Subject: Approval of software package 1.4.1.2 for ATIL make propulsion system

Subject: Details of changes, incorporated in software package 1.4.1.2

Responsible division: RSC	Responsible unit: PPC	Document type: Release Candidate Instructions	Confidentiality status: Public	ALSTOM
Prepared: 2024-05-02 M Vijay Anand	Title: Software Package Release Notes for Propulsion in WAG9/9H, WAP7, WAP5 Locomotives	Document state: Released	3EYP600299-2089	
Checked: 2024-05-02 K Manoj Kumar				
Approved: 2024-05-02 S Sourav	File name: 3EYP600299-2089_Gen_IR_PRPset_Software Package Release Notes_1.4.1.2	Revision: _H	Language: en	Pages: 1/25
Saved:		Sequence index:	1

Software Package Release Notes

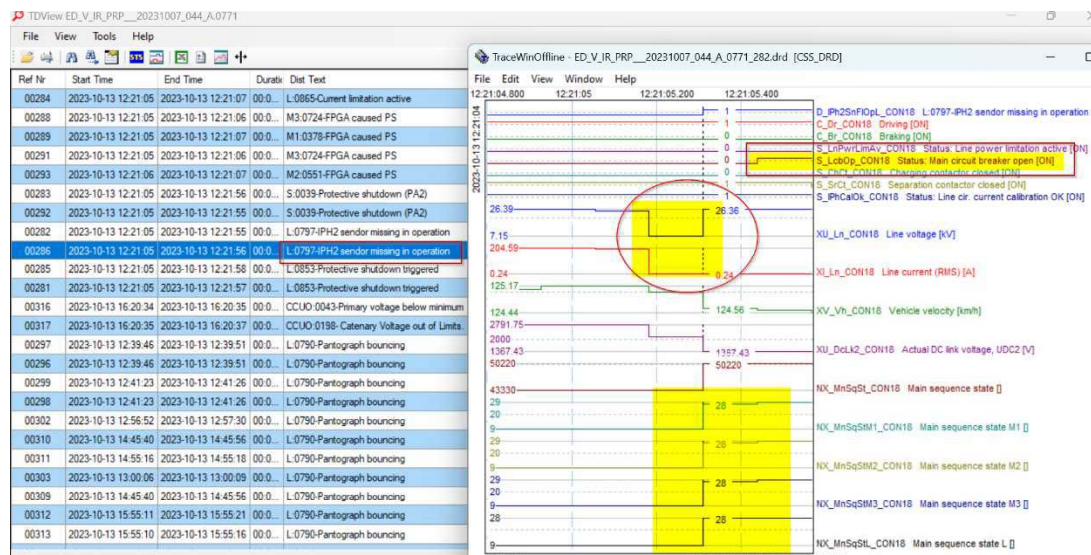
Problem Statement 1: Isolation of SR during energy saving mode activation in software package 1.4.1.1

Reason: In Software 6.0.4.13, in CCUO software below changes has been implemented to handle isolation of Traction converter due to the low coolant pressure condition.

1. When (VCB Command is given and VCB is closed for more than 20 sec) **AND** (Coolant pressure is Low for more than 20 sec) **and** (FLG Node is greater than or equal to 570) **and** (less than 596) then isolate the converter.
2. When FLG Node is 596 and Command to Pulse traction converter (line /motor) is raised and VCB is closed for more than 20 sec and coolant pressure is low for more than 16 sec , then CCUO shall open VCB with the fault message of coolant pressure below limit.

When the above action of opening VCB with disturbance of Coolant pressure low happens thrice within 30 mins of first fault then CCUO Shall isolate Traction Converter.

In first requirement we didn't add energy saving mode interlock. So, when ESM is activated on that time BUR has ramp down the coolant pump and CCU get Coolant pressure low feedback, so as per first requirement SR will be isolated when energy saving mode is activated.

Solution: Changes made in software i.e. Added ESM activated and deactivated interlock in coolant pressure logic (In 1st and 2nd requirement we added ESM activated and deactivated interlock)

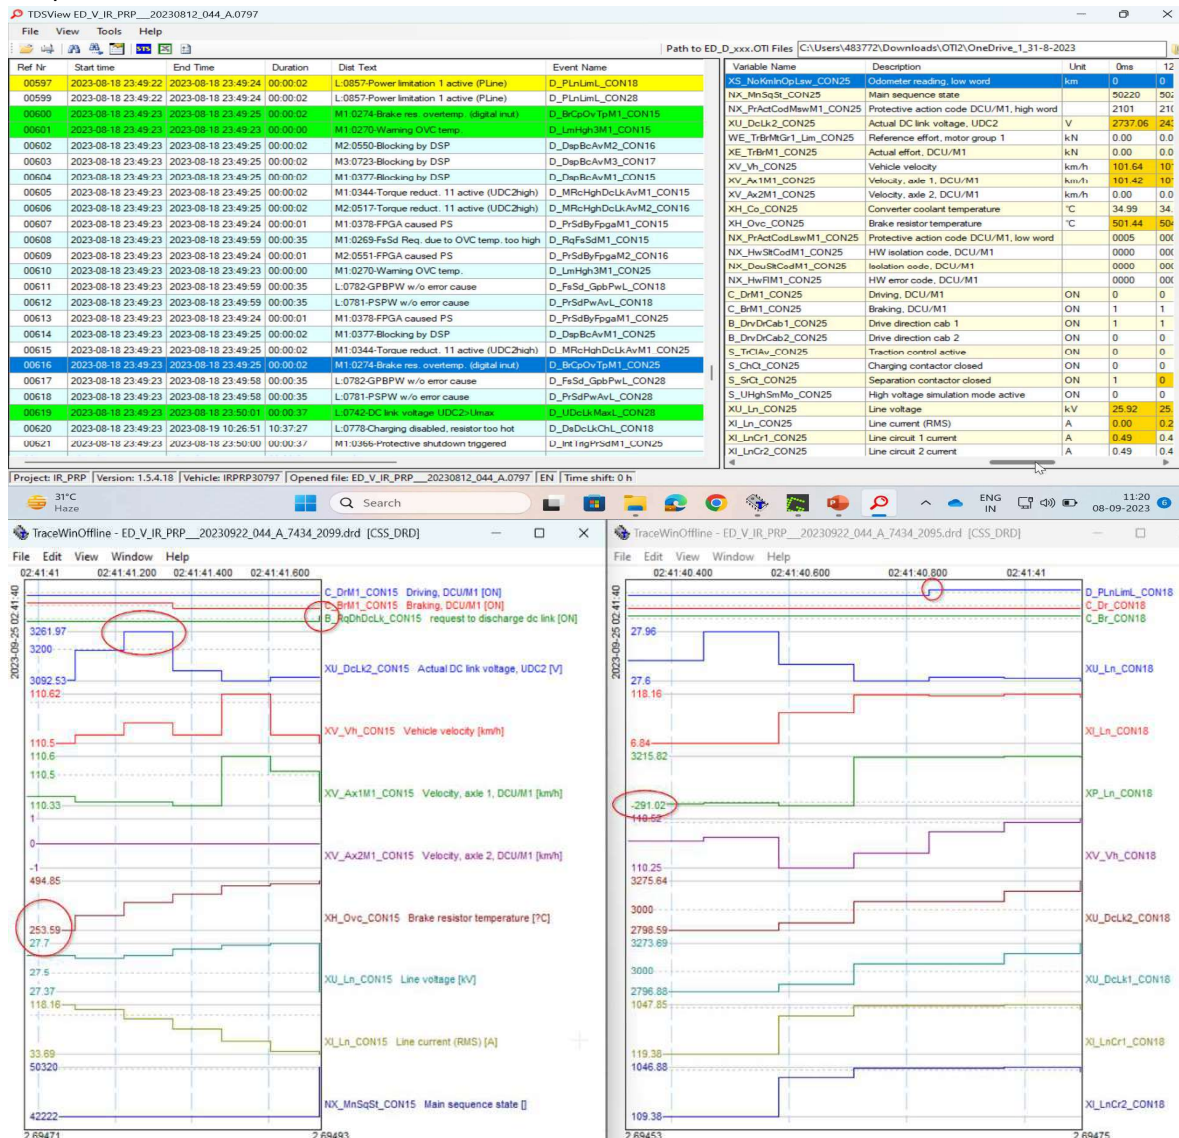
Problem Statement 2: When line voltage drop for short time then “loss of IPH sensor message” being generated during traction and as a result of protective shutdown was initiated. This cause to open LCB and “Disturbacne in converter message” pop up message is triggerred on DDU

RCA: While troubleshooting we found issue could be related to supervision timings. We conclude that if line interruption is there, is only can cause for Protective blocking not protective shutdown , to improve this we are change Parameter related to line supervision from 500ms to 45ms which can give use correct response as per system requirements.

Solution : When the line voltage is suddenly dropped below Minimum Voltage 16.5 KV for more than 45ms , then protective blocking is initiated for line and motor converter and this will nullify the chances of with Disturbance in converter pop up message

OVC related improvement: POD functionality

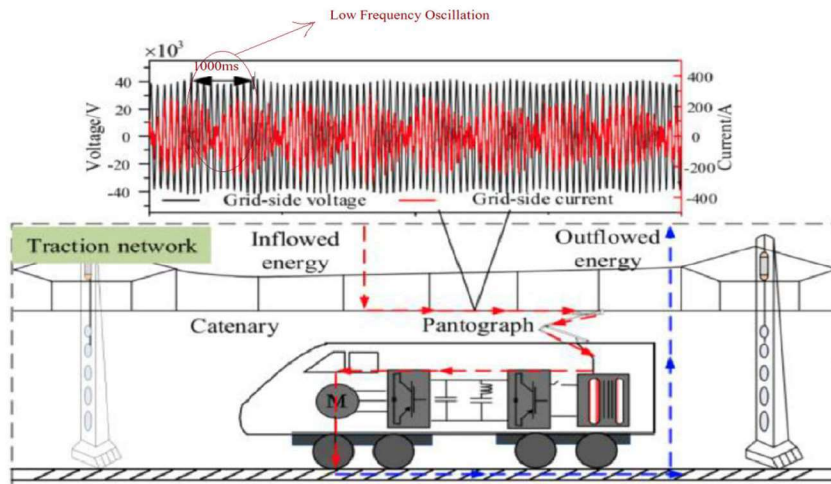
Problem Statement 3 : Traction converter isolation due to OVC temperature too high. DC link is getting higher is some special case , if it is higher then 3200Vdc Br-Rs chopper will fire and it can increase Brake resistor temperature.

RCA: in several case study for OVP related issues most common thing we found is “It will happen only when Power limitation is active and Train is in braking mode”. During this time- DC link Voltage is getting higher than nominal operating condition and when it crosses 3200, OVP fires and Energy gets dissipated on OVP resistor.

Solution: Stabilization of DC link voltage through tuning of 4QC and implementation of power oscillation damping logic (POD)

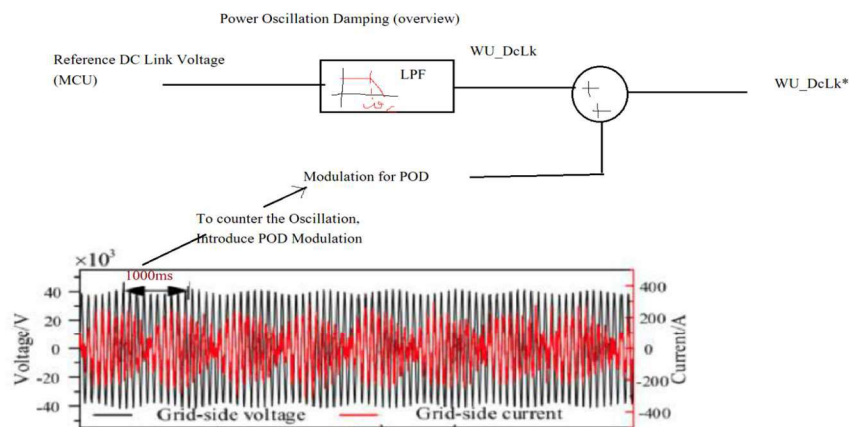
Problem Statement: While RCA for OVC related issue, we also found one more improvement will be introduced for DC link reference.

RCA: Low frequency oscillation on Line voltage could be effect the DC link voltage fluctuation .

Solution: Introduce POD function in addition to LPF to eliminate effect on DC link reference.
